**RFB-2022-22**  
**NISKAYUNA LIBRARY PARKING IMPROVEMENTS**

**ADDENDUM #1**

Issued Date 3/18/22

PARKING LOT PAVING PLAN

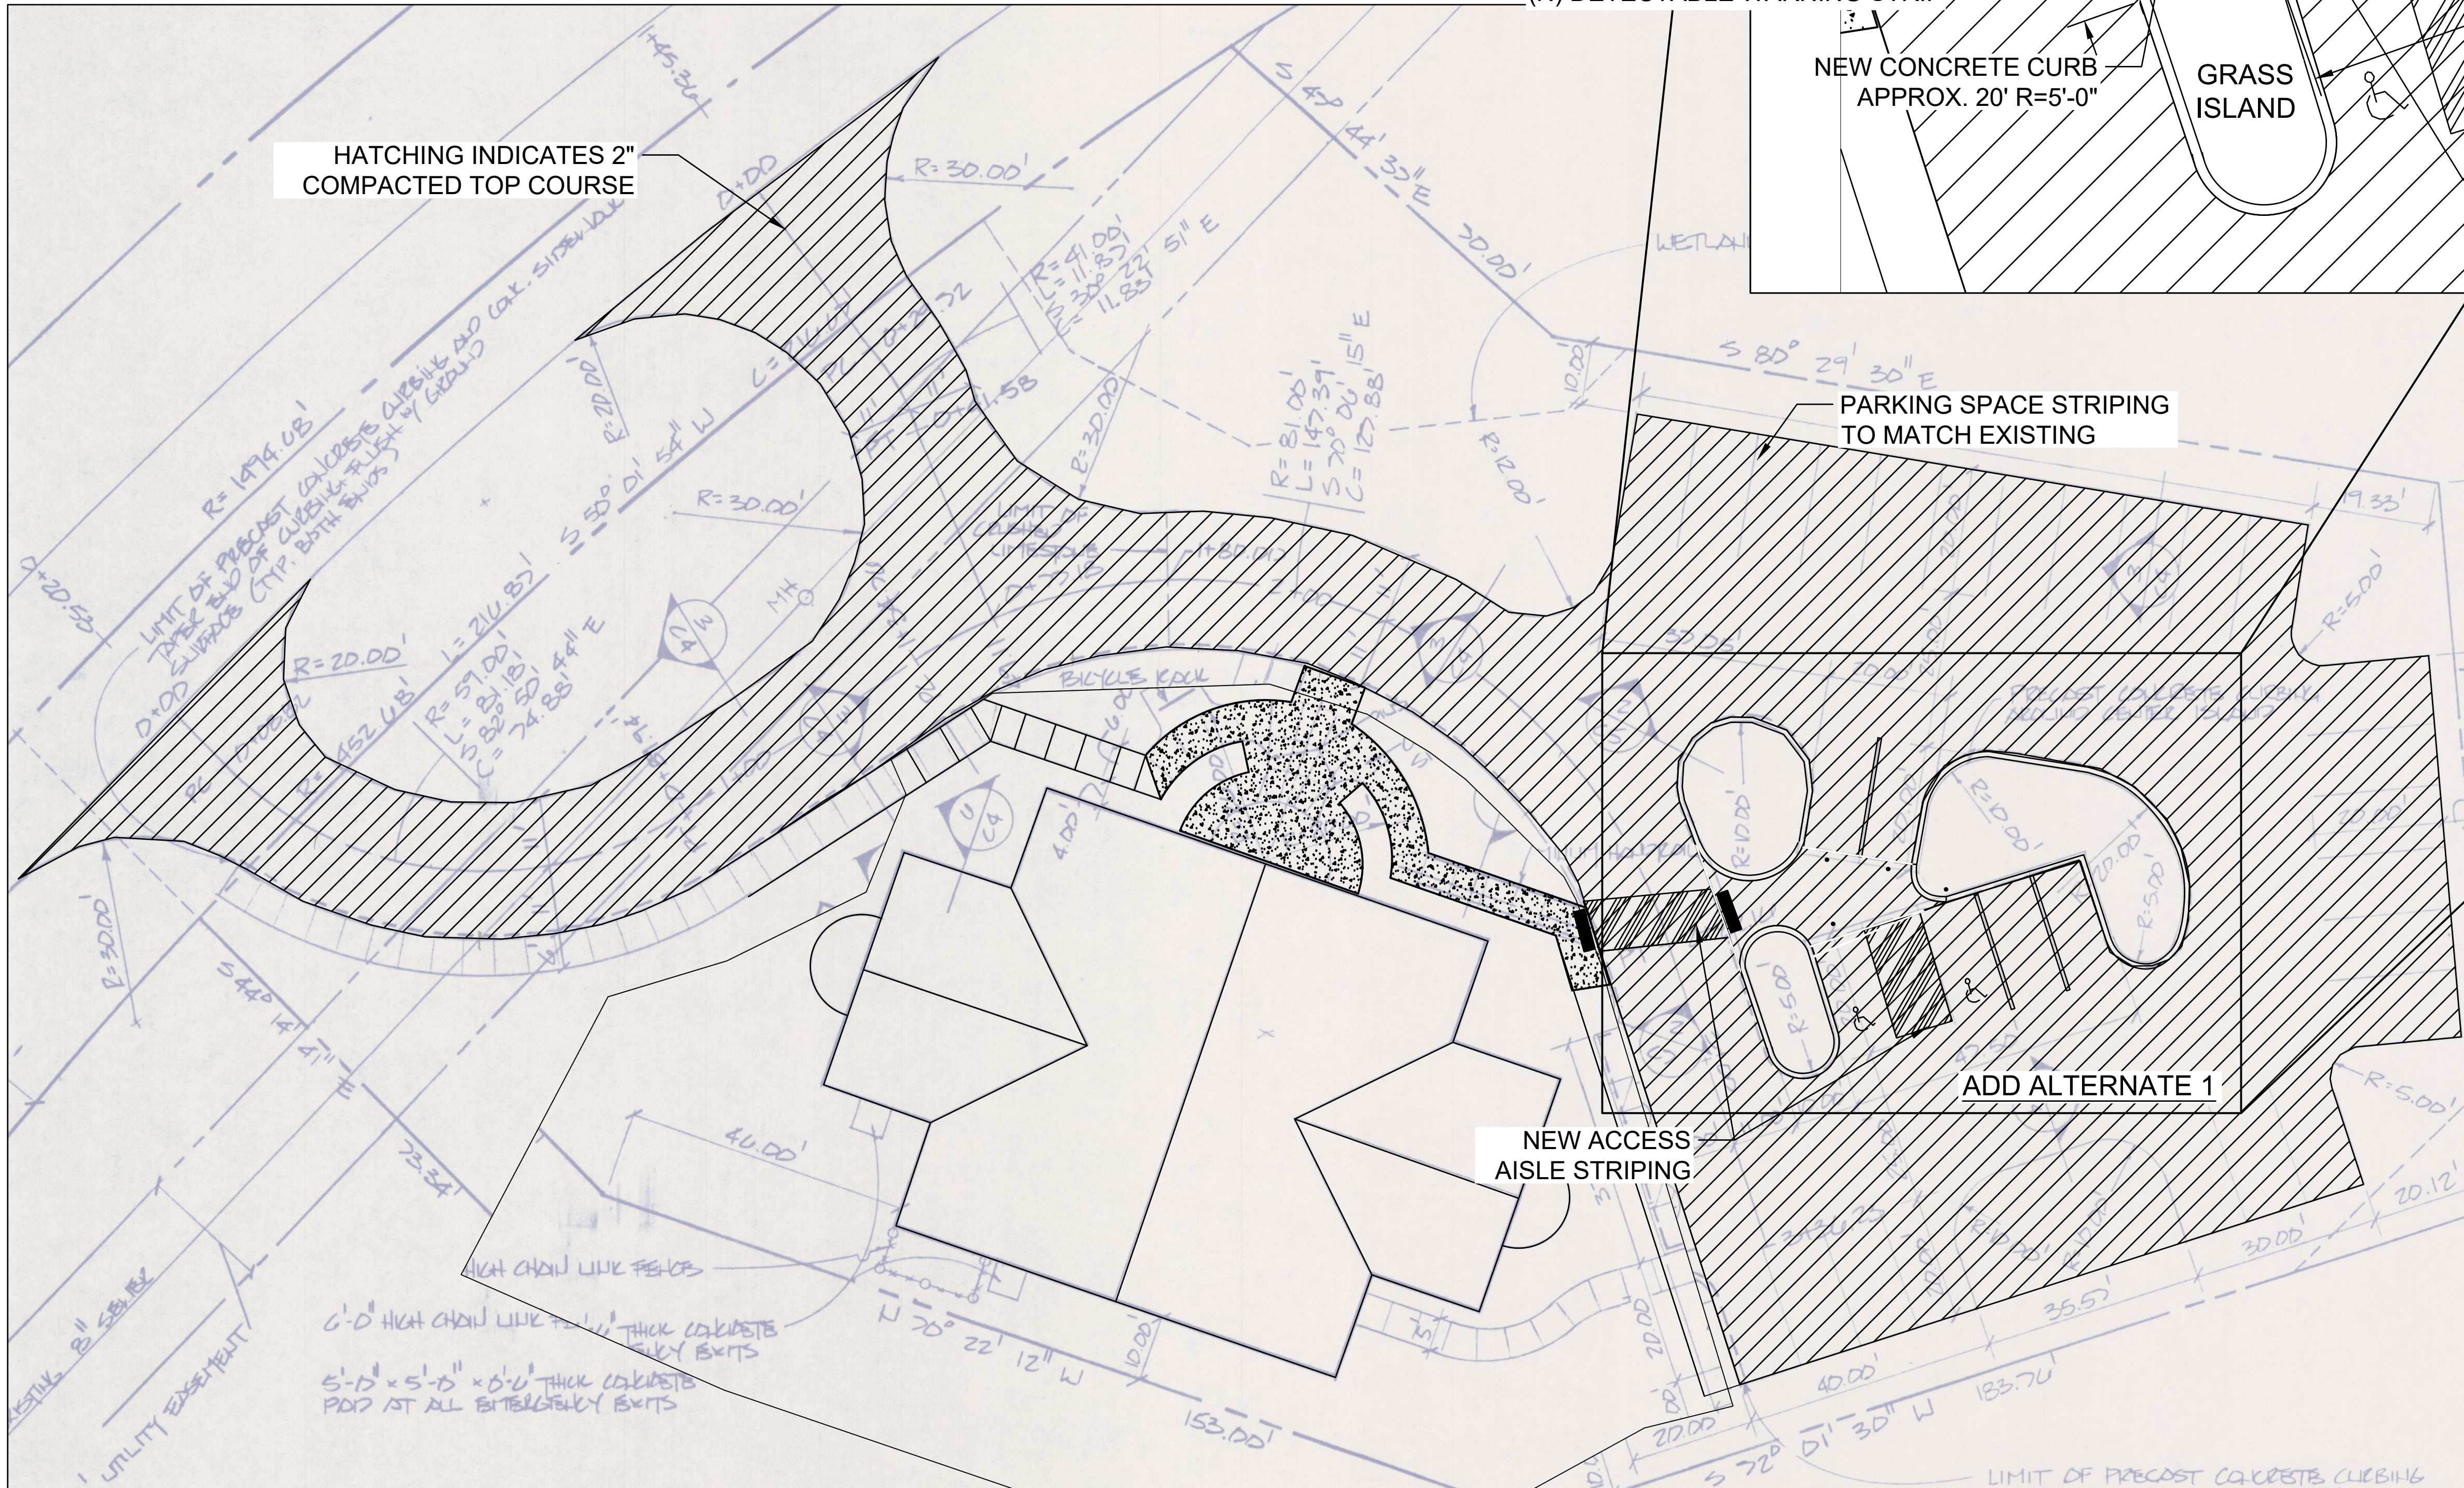
**Question 3:** This area was discussed verbally at the walk thru as being removed and replaced. Please confirm this area is to be replaced.

**Answer 2:** See attached Revision A for extended/reduced sidewalk area.
